UNITED STATES PATENT AND TRADEMARK OFFICE

APPLICATION NO.	FILING DATE	FIRST NAMED INVENTOR	ATTORNEY DOCKET NO.	CONFIRMATION NO.
10/650,321	08/27/2003	David Hancock	COMPN-65227	6881

Office Action Summary

DETAILED ACTION

FIG. 1

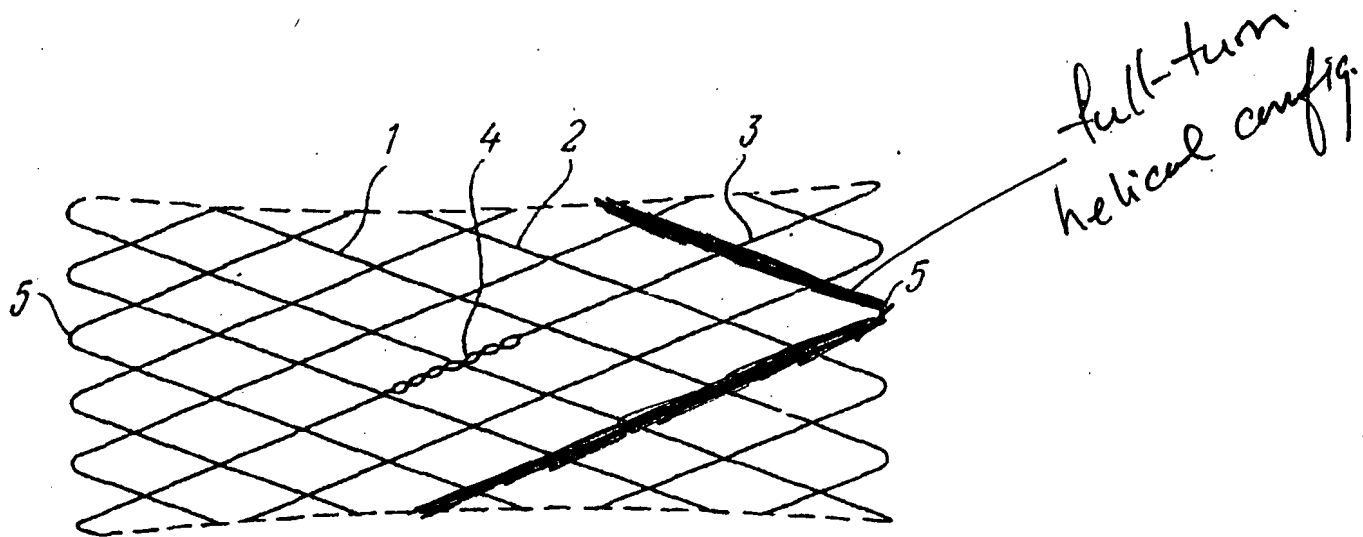
After a careful examination of the applicant's new limitations and remarks the Examiner maintains the previous rejection. The Examiner has interpreted the limitations "a full-turn helical configuration" as follows: as shown in Figures 1-3 and the specification, the fiber (1) clearly extends through out the circumference of the stent by helically wounding the fiber around the surface of the stent (see attachment).

Regarding the Applicant's remarks, the examiner understand the Applicant's point of view, however, the Applicant's representative has to enter more limitations in order to limit the full-turn helical configuration at the first or second ends of the tubular body.
